QVM BULLETIN: Q-316

2019 - 2020MY RANGER BOX DELETE FRONTAL AREA RESTRICTIONS

REVISION	UPDATE	REVISION DATE
Q-316	INITIAL RELEASE	11 / MAY / 2020

FIGURE A – SECOND UNIT BODY RADII RESTRICTIONS FOR ENHANCED FRONTAL AREA

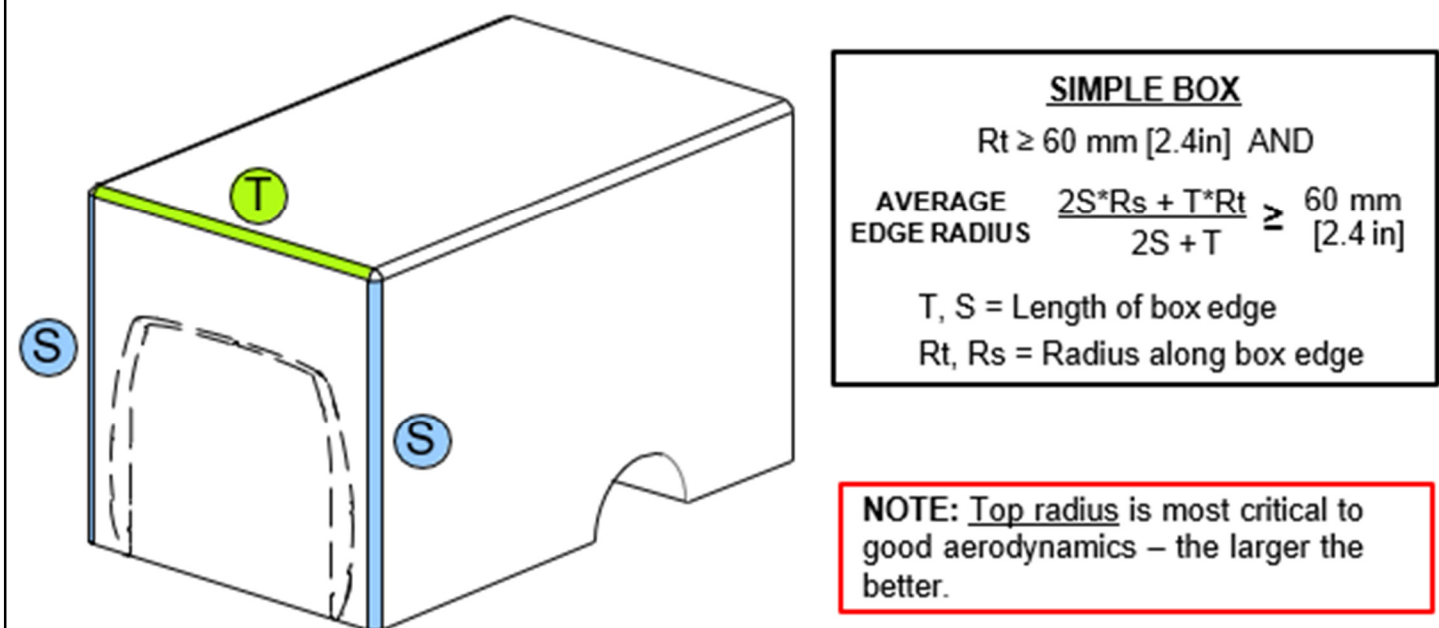
Based upon a review of anticipated body builder designs, the Ranger Box Delete Frontal Area restrictions are being revised to reflect updated aerodynamics analysis, as follows.

- Up to 3.75 m² [40.3 ft²] with no radii restrictions
- Greater than 3.75 m², up to 4.12 m² [44.3 ft²] must meet radii restrictions shown in **Figure A**.
